TO: DEVELOPMENT REVIEW BOARD **DATE:** September 18, 2003
FROM: CURRENT PLANNING SERVICES
SUBJECT: CASE 58-DR-2003
REQUEST: Approve site plan & elevations for an automobile sales facility
PROJECT NAME: Bill Heard Chevrolet
LOCATION: 8705 E McDowell Rd

REQUEST: This is a request to approve the site plan and elevation of a new automobile sales facility.

Stipulations for Case: Bill Heard Chevrolet Case 58-DR-2003

SITE PLAN

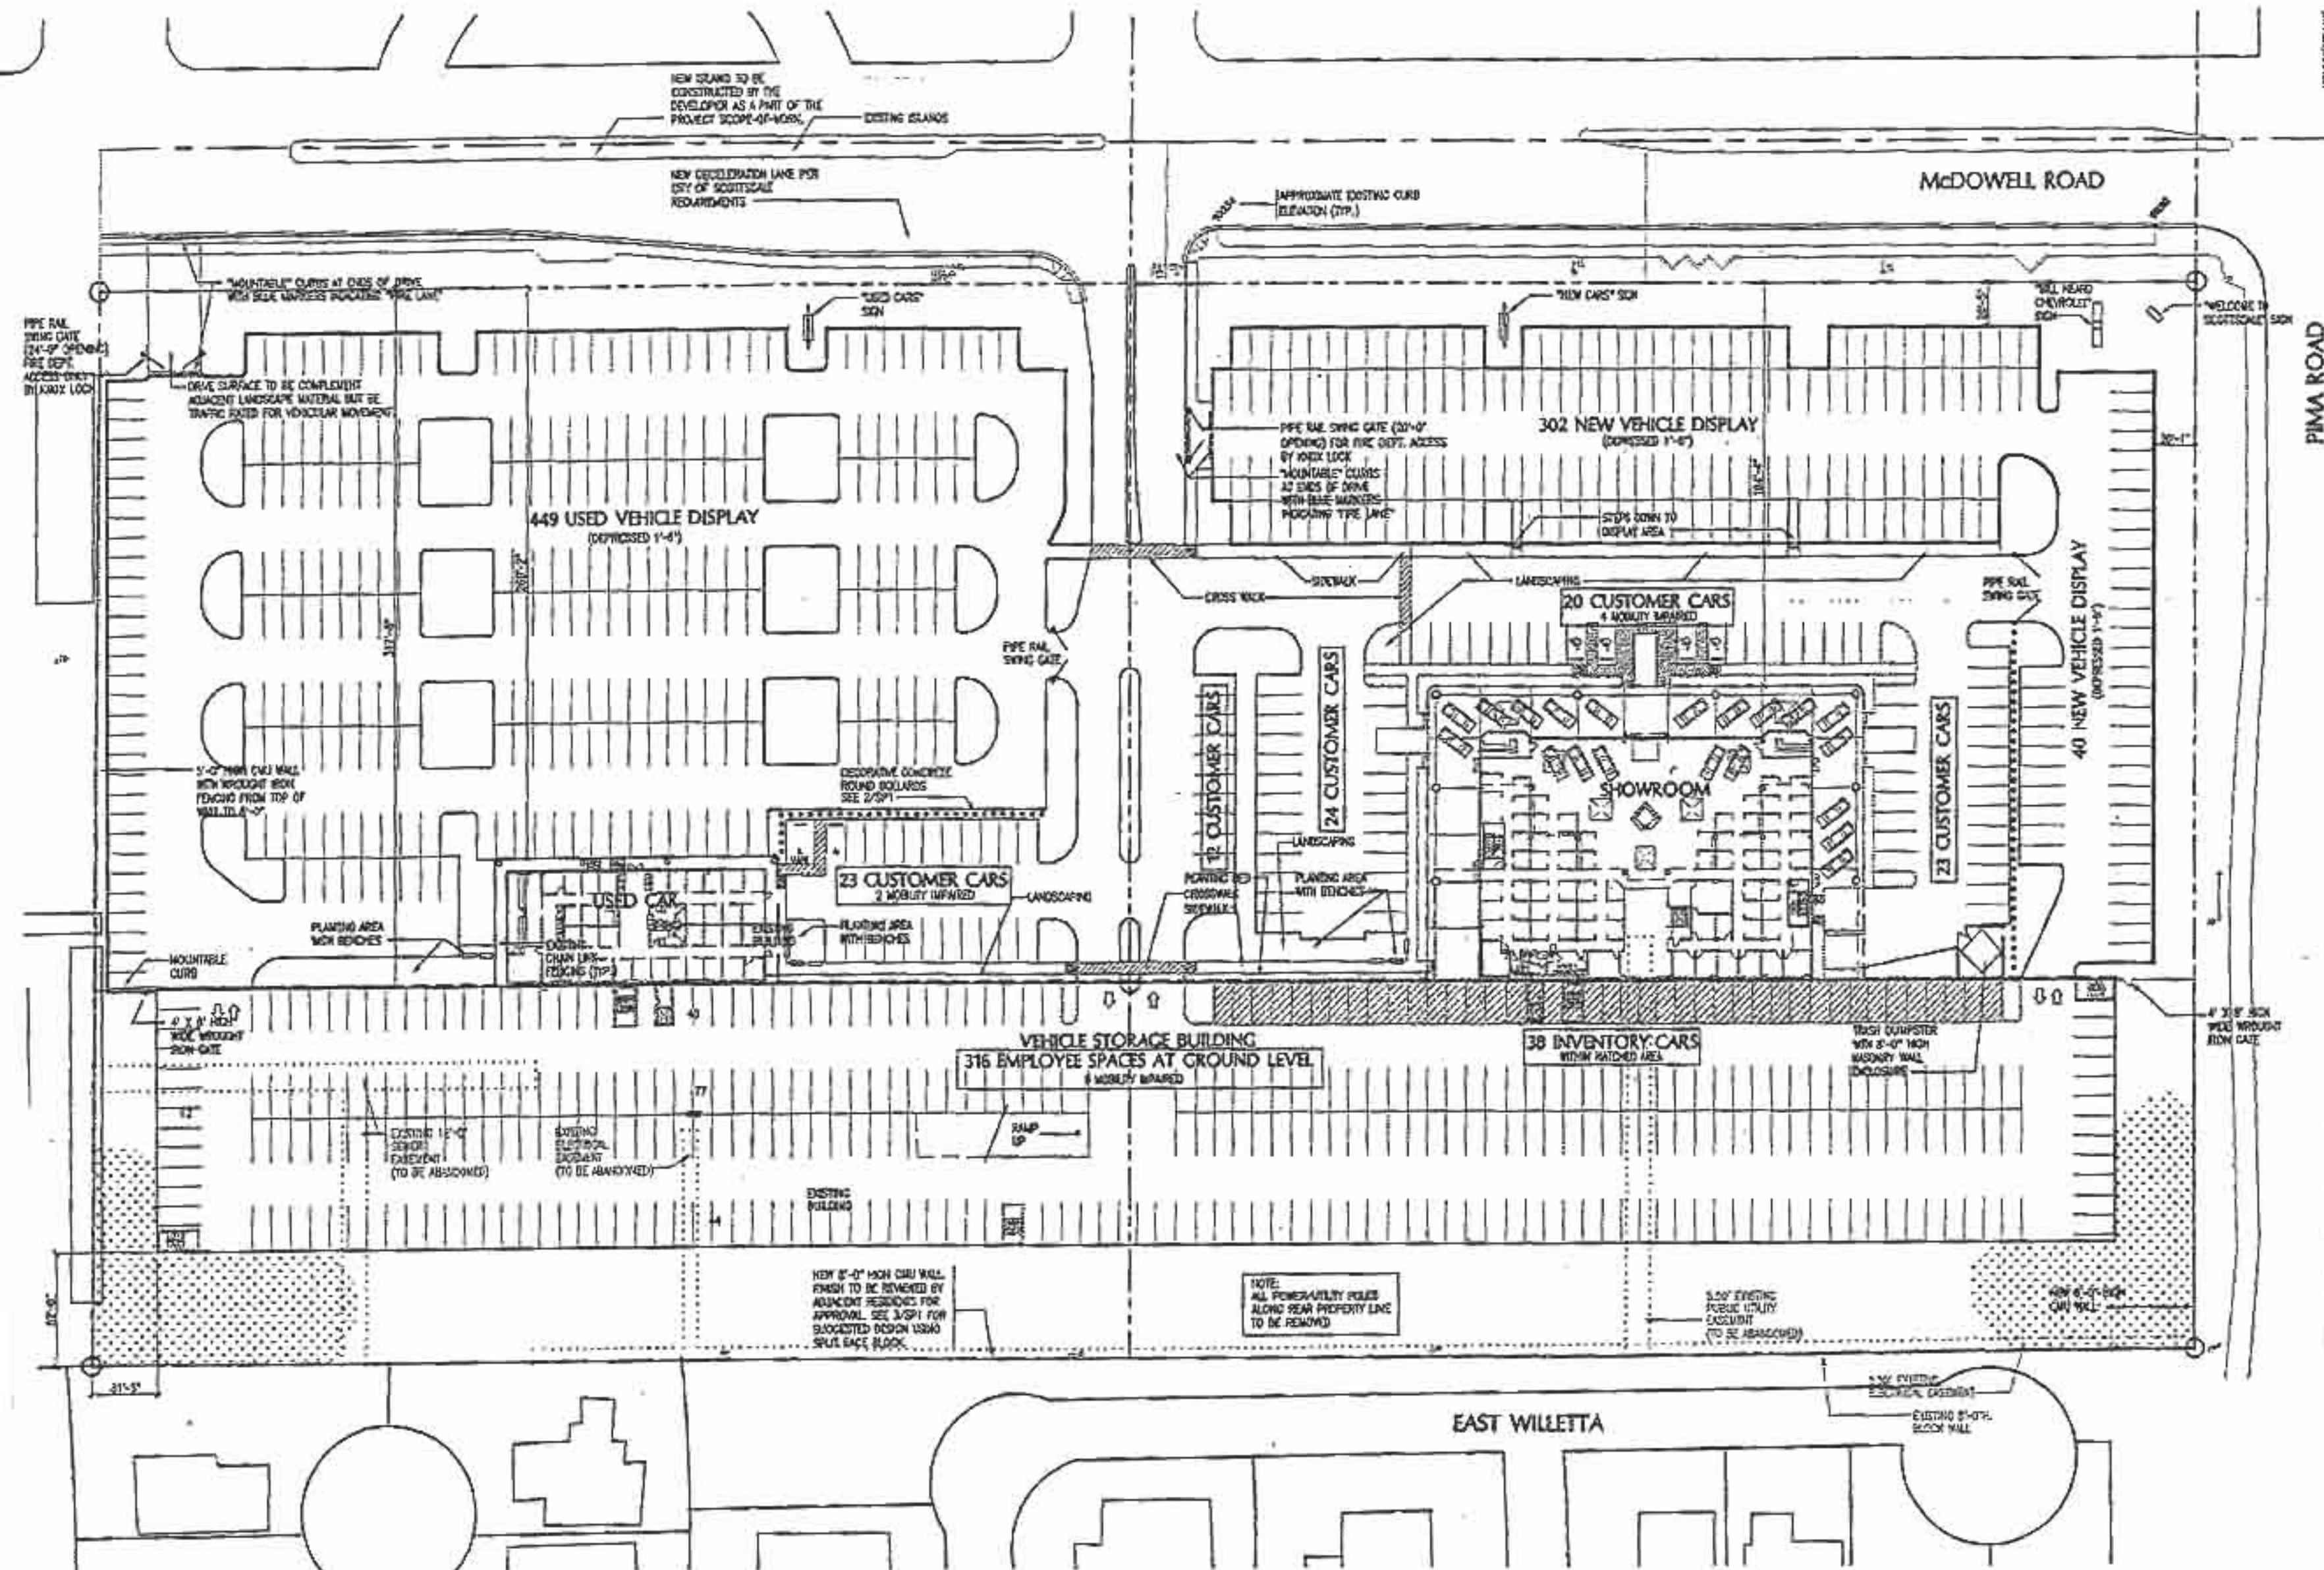
12. With the final plans submittal, the developer shall submit a revised site that clearly shows all existing and proposed easements. A "Gateway Design Feature" easement shall be shown at the southwest corner of McDowell and Pima Roads. The dimensions of the easement shall be in conformance with stipulation number 8 of case 30-UP-2002 under Planning/Development.

- B. Volume calculations (allowed volume and provided volume) shall be shown in the project data table on the site plan for all buildings and parking structures on site. Building volume shall be calculated as defined in the Scottsdale Zoning Ordinance.

- C. The maximum allowed area for auto display shall not exceed 20% of the total net lot area. With the final plans submittal, the developer shall submit a detailed site plan worksheet graphically showing compliance with this requirement.

2 SHOWROOM ELEVATION

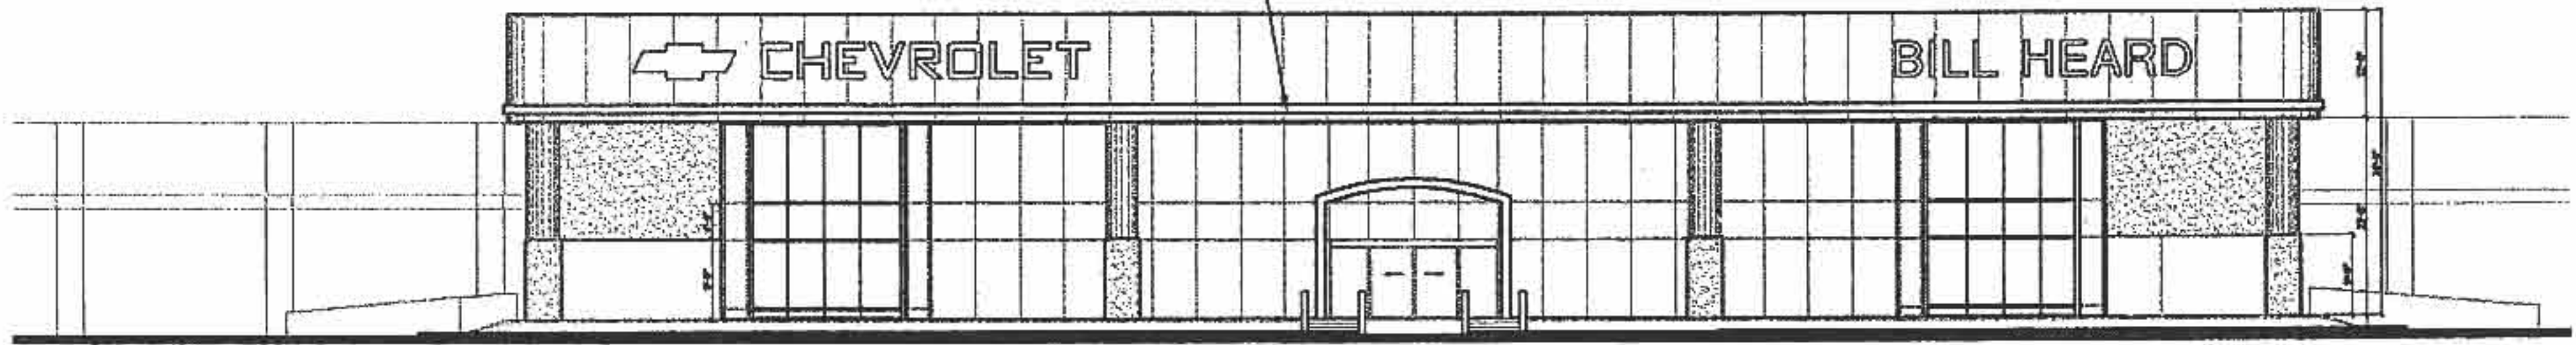
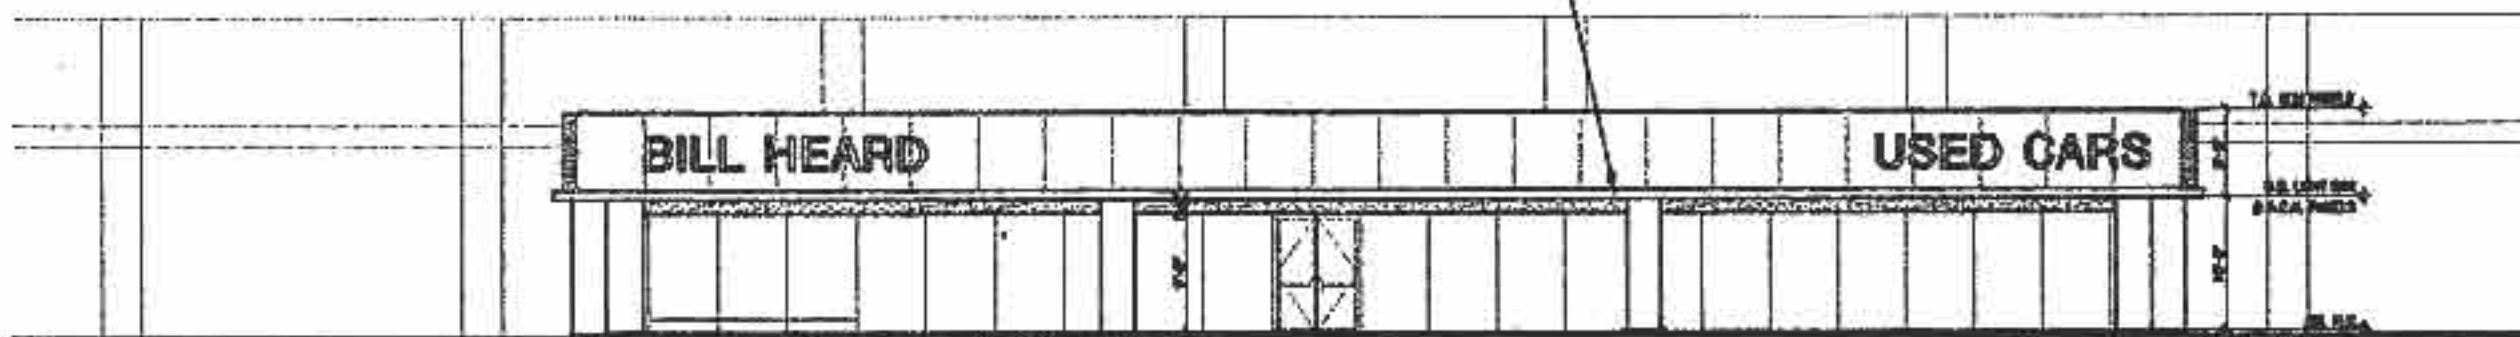
10. The base (lower 9 feet) of the canopy columns on the showroom canopy shall be wider than the top of the columns.

- 24. All interior building lighting visible from the exterior of the building, shall be reduced to security levels during the post-curfew hours.
- 25. The blue band running the length of facility shall be opaque and may be backlit. The lamp and the lamp source shall not be visible through the band or from off site.
